# Access Compliance Report

## Public Rights-of-Way

Intersection ID: 12114	Main Street: ROBINSON_CHURCH_RD	Cross Street: TEANECK_PL	Location: SE
ADA ID: BA7C13005404	Ramp Type: Perp	Initial Pass/Fail: Fail	Overall Compliance: No
		Severity Score: 25

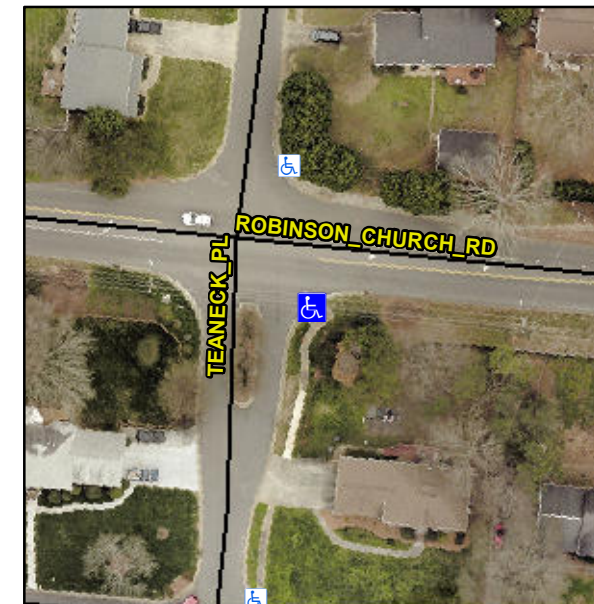
**Not Found, R304.5.3**

Compliance	Description	Data	Compliance	Description	Data
N/A	Ramp Length (in)	60.0	Yes	Ramp Slope (%)	7.2
Yes	Ramp Width (in)	51.0	No	Ramp XSlope (%)	7.3
N/A	Flare Type LT	N/A	N/A	Flare Type RT	N/A
N/A	Flare Slope LT (%)	N/A	N/A	Flare Slope RT (%)	N/A
N/A	Flare Traversable LT?	N/A	N/A	Flare Traversable RT?	N/A
N/A	Landing Length (in)	N/A	N/A	DWS Provided?	N/A
N/A	Landing Width (in)	N/A	N/A	DWS Contrast?	N/A
N/A	Landing Slope (%)	N/A	N/A	DWS Length (in)	N/A
N/A	Landing X Slope (%)	N/A	N/A	DWS Full Width?	N/A
N/A	Landing Curb? (Y/N)	N/A	N/A	DWS Offset (in)	N/A
N/A	Shared Landing?	N/A			
N/A	Gutter Ponding?	N/A	N/A	Gutter Slope (%)	N/A
N/A	Gutter Lip Ht (in)	1.0	N/A	Gutter X Slope (%)	N/A
N/A	Painted X Walk1?	No	N/A	Painted X Walk2?	N/A
	X Walk 1 Direction	To N		X Walk 2 Direction	N/A
N/A	X Walk 1 Width (in)	N/A	N/A	X Walk 2 Width (in)	N/A
	X Walk 1 Slope (%)	4.2		X Walk 2 Slope (%)	N/A
	X Walk 1 X Slope (%)	6.0		X Walk 2 X Slope (%)	N/A

**Remove & Replace Entire Ramp.**
